# Access Compliance Report

## Public Rights-of-Way

Intersection ID: 19048	Main Street: CORY-BRET_LN	Cross Street: SHOPTON_RD_WEST	Location: SW
ADA ID: 170201DB79CC	Ramp Type: PerpDiag	Initial Pass/Fail: Fail	Overall Compliance: No
Severity Score: 25			
Codes/Mitigation Info/Possible Solution		Field Measurements/Component Compliance

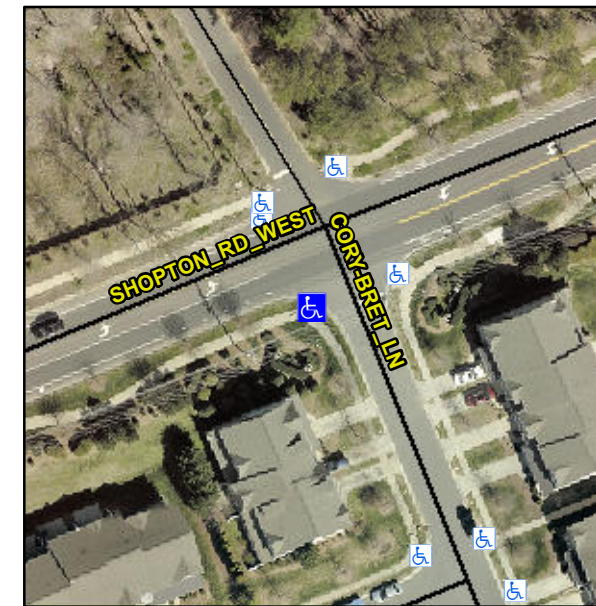
**Not Found, R304.5.3**

Compliance	Description	Data	Compliance	Description	Data
N/A	Ramp Length (in)	54.0	Yes	Ramp Slope (%)	7.6
Yes	Ramp Width (in)	53.0	No	Ramp XSlope (%)	7.1
N/A	Flare Type LT	N/A	N/A	Flare Type RT	N/A
N/A	Flare Slope LT (%)	N/A	N/A	Flare Slope RT (%)	N/A
N/A	Flare Traversable LT?	N/A	N/A	Flare Traversable RT?	N/A
N/A	Landing Length (in)	N/A	N/A	DWS Provided?	N/A
N/A	Landing Width (in)	N/A	N/A	DWS Contrast?	N/A
N/A	Landing Slope (%)	N/A	N/A	DWS Length (in)	N/A
N/A	Landing X Slope (%)	N/A	N/A	DWS Full Width?	N/A
N/A	Landing Curb? (Y/N)	N/A	N/A	DWS Offset (in)	N/A
N/A	Shared Landing?	N/A			
N/A	Gutter Ponding?	N/A	N/A	Gutter Slope (%)	N/A
N/A	Gutter Lip Ht (in)	N/A	N/A	Gutter X Slope (%)	N/A
N/A	Painted X Walk1?	No	N/A	Painted X Walk2?	No
	X Walk 1 Direction	To E		X Walk 2 Direction	To NW
N/A	X Walk 1 Width (in)	N/A	N/A	X Walk 2 Width (in)	N/A
	X Walk 1 Slope (%)	2.0		X Walk 2 Slope (%)	10.4
	X Walk 1 X Slope (%)	6.3		X Walk 2 X Slope (%)	0.0

**Remove & Replace Curb Ramp With Two New Directional Ramps or Equivalent.**
